SERVICE BULLETIN

Classification: HA20-002	Reference: NTB20-098	Date: December 23, 2020
-----------------------------	-------------------------	----------------------------

2017-2018 ROGUE SPORT; NO AIR FLOW FROM HVAC VENTS DUE TO SNOW BUILD-UP

APPLIED VEHICLES: 2017-2018 Rogue Sport (J11)

Figure 1

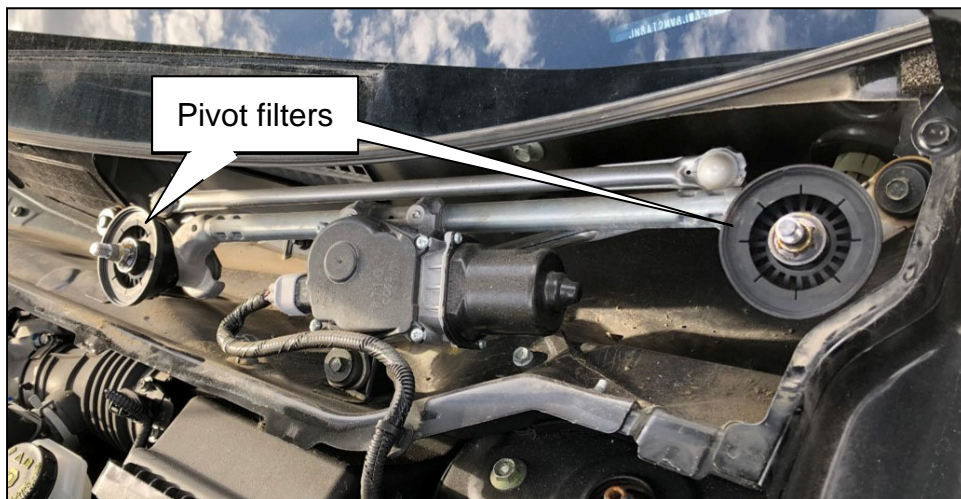
1. Remove all snow, water, and any debris from the HVAC intake, cowl area, and where the blower motor mounts.
 - For removal of the cowl top cover and related parts, refer the Electronic Service Manual (ESM), section **BODY EXTERIOR, DOORS, ROOF & VEHICLE SECURITY – EXTERIOR – REMOVAL AND INSTALLATION – COWL TOP**.
2. Clean or replace the blower motor as needed.
3. If not already equipped, install a wiper pivot filter on each wiper pivot (see Figure 1).
 - See **PARTS INFORMATION** on the last page of this bulletin.

Make sure to install both wiper pivot filters. If the wiper pivot filters are not installed, snow may enter the blower motor inlet and cause damage to the blower motor.

Figure 2

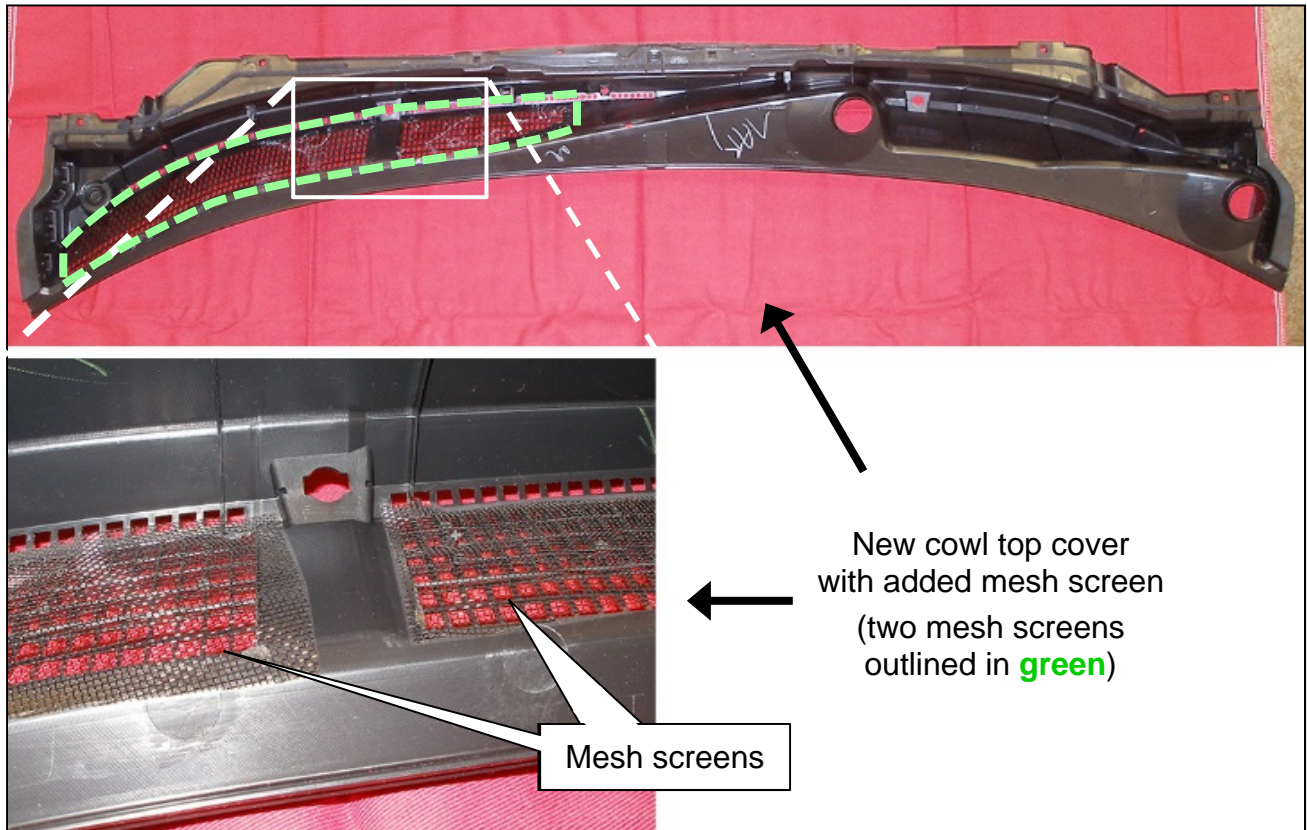
4. Reassemble the vehicle using the new cowl top cover listed in the **PARTS INFORMATION**.

Make sure to install the new cowl top cover listed in the **PARTS INFORMATION**. If the new cowl top cover is not installed, snow may continue to enter the blower motor inlet and cause damage to the blower motor.
